Product Support Bulletin 2008-003

DATE:	June 6, 2008	
SUBJECT:	Battery Cables Secured to Hydraulic Hoses Anti-abrasion Sleeve Kit – 98411100	
RATING:	X DIRECTIVE (Action is required)	ALERT (Potential Problem)
	INFORMATION (Action is optional)	PRODUCT IMPROVEMENT (Enhance Product)
MACHINE MODEL(S):	All Nordco Machines Equipped with a Battery	
SERIAL NUMBER(S):	All (including RBUG machines)	
SUMMARY:	The positive battery cable from the battery to the starter connection on the engine may be secured to a hydraulic hose with cable ties. Because of the vibrations of the hose, the cable insulation and outer hose covering may wear through causing a short circuit with the wire braid of the hose. This also applies to cables connected from the battery to the Electric Emergency Pump if the machine is so equipped. See Figure 3 on Page 3.	
OPERATIONAL IMPACT:	If the battery cable shorts out to the hose, the hose may burst. Pressurized hydraulic oil spraying out of the hose could be ignited from the heat generated by the short circuit and start a fire. Figure 1 on Page 2 shows a worn cable.

Figure 2
Cables in Clamps & Covered with Anti-abrasion Sleeve

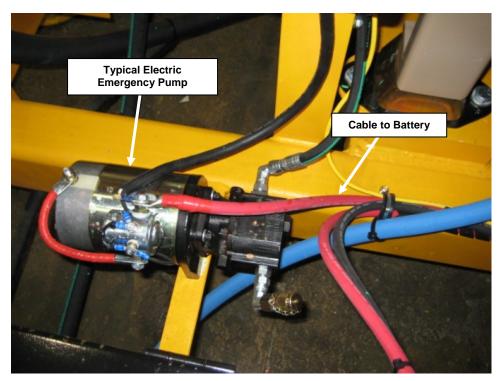
The clamps are welded to the frame of the machine as required. See Figure 2 on Page 3. Be sure to follow all Lock Out-Tag Out procedures before welding. Consult your machine manual for specific Lock Out-Tag Out procedures.

The various machines all have different battery, emergency pump and engine locations, so cable routing will vary for the different machine models. However, the battery cable clamps should be placed no more than 3 feet apart and the cables should be routed to avoid sharp edges of the engine and frame. Some machines, especially older Grabber Spike Pullers with the battery mounted at the rear of the machine may need 2 kits, but most machines will only require 1 kit.
